IEEE 802.11
Wireless Access Method and Physical Specification

Title: **Proposal to change the Element format.**

Abstract: This document proposes a different format for the "Element" field, to allow the use of short codes with less overhead, and to allow a larger parameter field in a single element.

New "Element" field structure proposal:

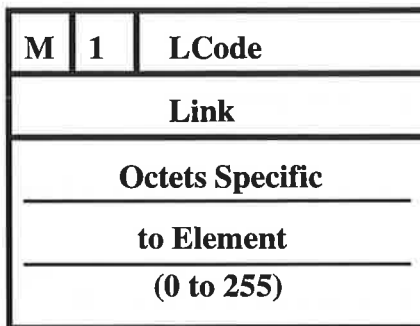
An element structure is proposed that allows two types:

- A Short Element format, that only requires one octet.
- A Long Element format, that uses a minimum of two octets.
This format can handle parameter fields up to a length of 255 octets.

bits: 1 1 3 3

More bit M =1: More Elements Follow
 =0: Last Element

SCode: Short Element Code (8 Codes)

Link (3 bits): number of subsequent octets

bits: 1 1 6

More bit M =1: More Elements Follow
 =0: Last Element

LCode: Long Element Code (64 Codes)

Link (8 bits): number of subsequent octets
